AES-0-NRC-09-00055-0

AREVA Enrichment Services LLC
Eagle Rock Enrichment Facility
NRC Docket No: 70-7015

Subject: Notice of Organization Change for the Eagle Rock Enrichment Facility
License Application

Attachment 1 – AES Organization Change, Marked-up Pages for the Safety Analysis Report and Quality Assurance Program Description

Figure A-2 **Rev. 1a**
Engineering, Procurement and
Construction (EPC) Organizational Chart
EAGLE ROCK ENRICHMENT FACILITY
QUALITY ASSURANCE PROGRAM DESCRIPTION

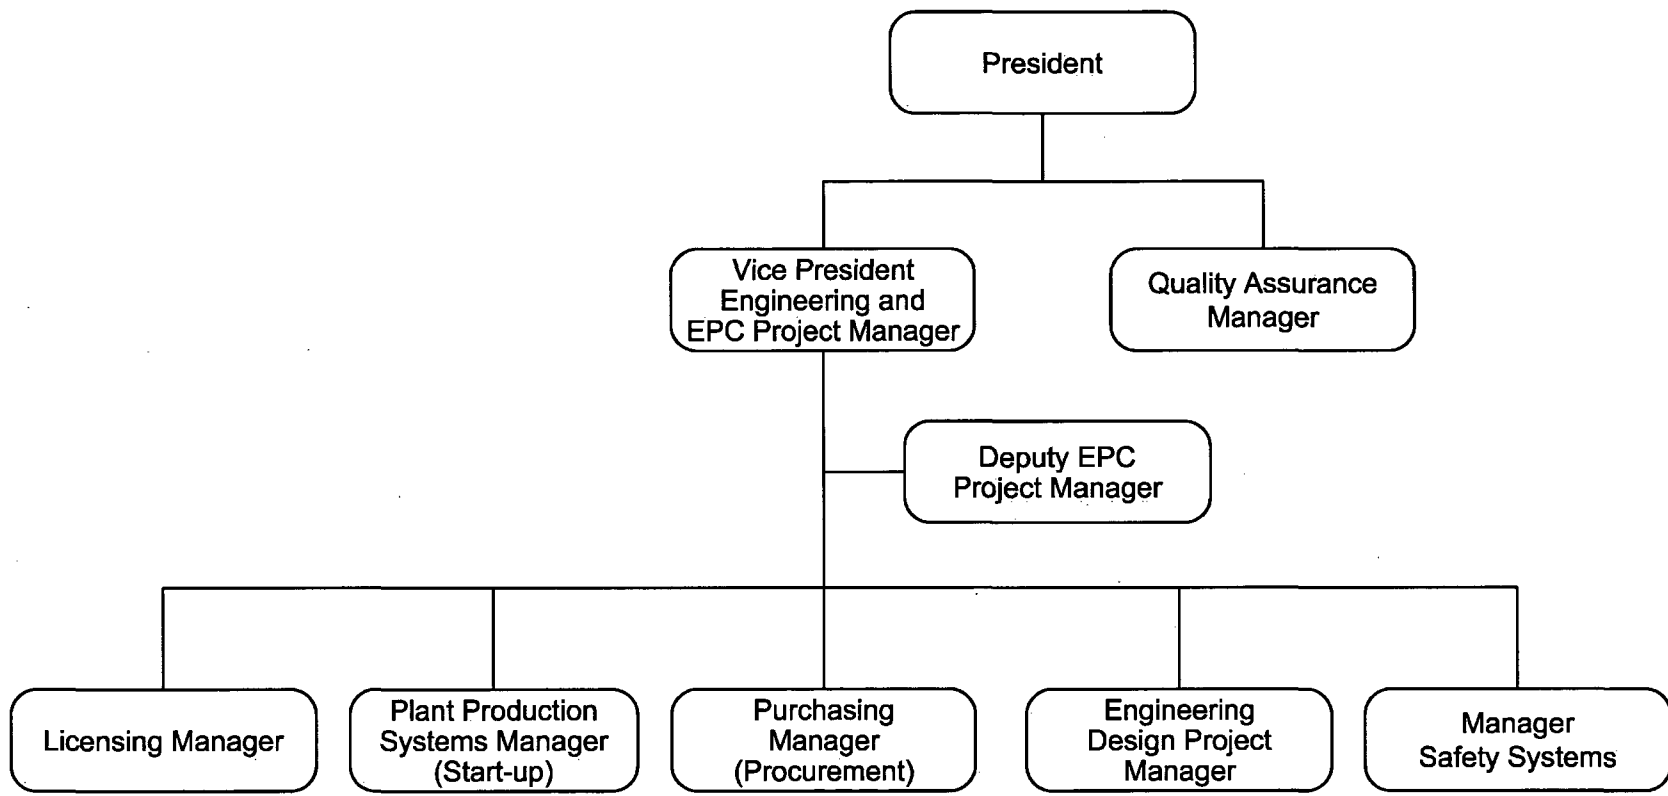
1.1.3 Figure A-2 of the QAPD shows the engineering, procurement, construction, and initial start-up organization of the EREF.

1.2.3 The AES President has designated the Vice President Engineering and Engineering, Procurement and Construction (EPC) Project Manager the responsibility for design, construction, procurement, and initial start-up for the Eagle Rock Enrichment Facility. The QAPD is binding on all AES and contractor personnel involved with the Eagle Rock Enrichment Facility.

1.2.4 A Deputy EPC Project Manager may assist the EPC Project Manager in planning and implementation of EPC activities.
